PCN: V15-123-BASE-A

Product Change Notice

PCB Related Change: Change of Plating Process.

ALM-2812-TR1G
ALM-2812-BLKG

Current	New
Bottom View

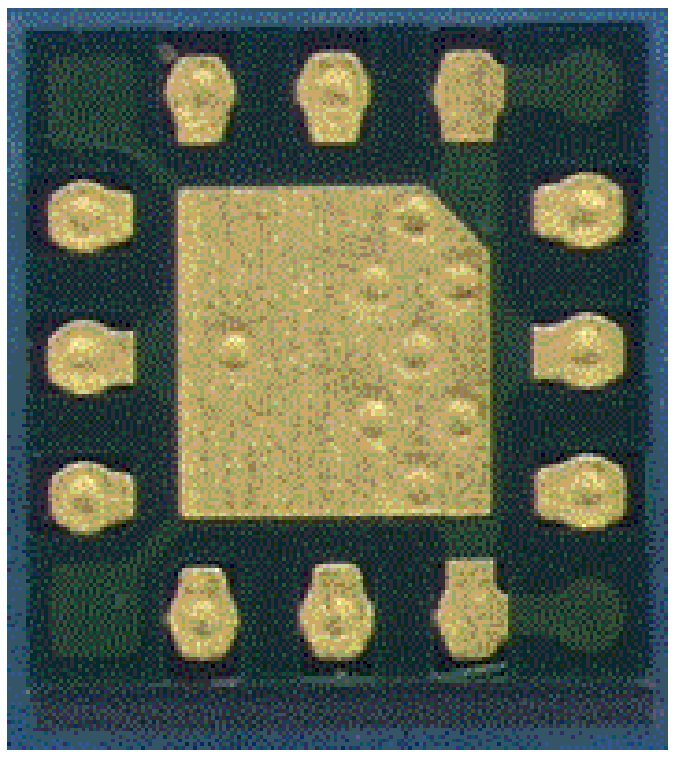
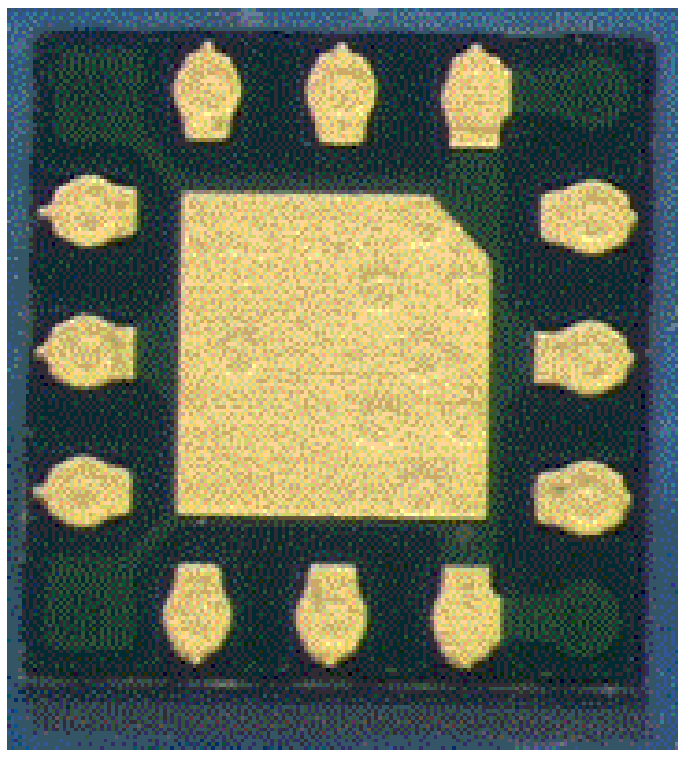
Supplier is changing the thick Ni-Au Electroless Immersion process to the Electrolytic Ni-Au etch back process due to obsolescence of the Electroless Immersion process.
